Technical Service Bulletin

Subject: WRONG VEHICLE LOCATION IN GPS WITH DTCS B119F:01, B119F:13 AND/OR B119F:2B STORED	Bulletin No.: 09-021/20
	Last Issued: 11/16/2020

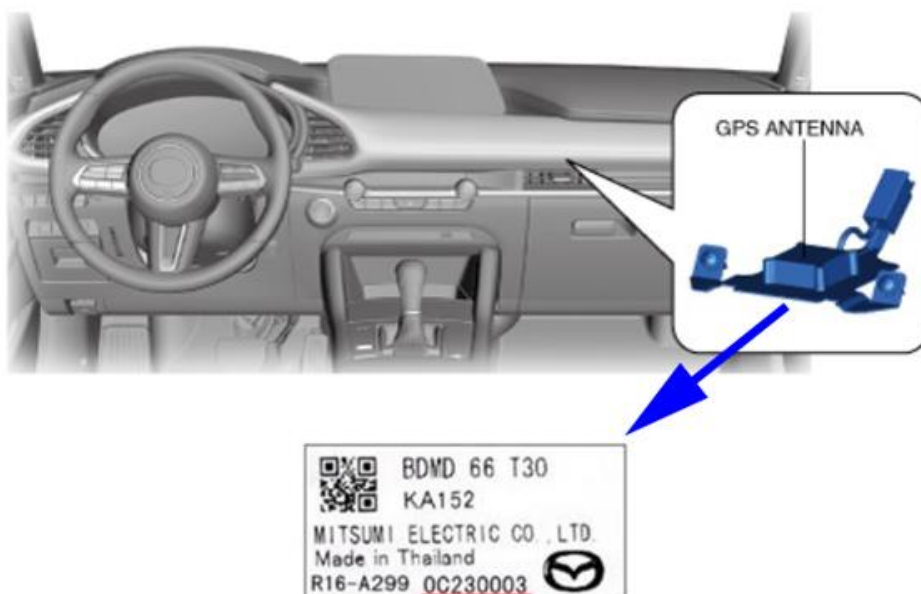
1. Verify customer concern.
2. Confirm if the telephone antenna No.1's lot number is before 0C230003. The lot number is in YMDDnnnn format.

NOTE: The part number has not been changed for this modification.

- If the lot number is 0C230003 or later, the part is already modified.
- If the lot number is before 0C230003, replace the GPS antenna with a modified one by referring to the instructions on MGSS.
 - Mazda3: (GLOBAL POSITIONING SYSTEM (GPS) ANTENNA REMOVAL/INSTALLATION)
 - CX-30: (GLOBAL POSITIONING SYSTEM (GPS) ANTENNA REMOVAL/INSTALLATION)
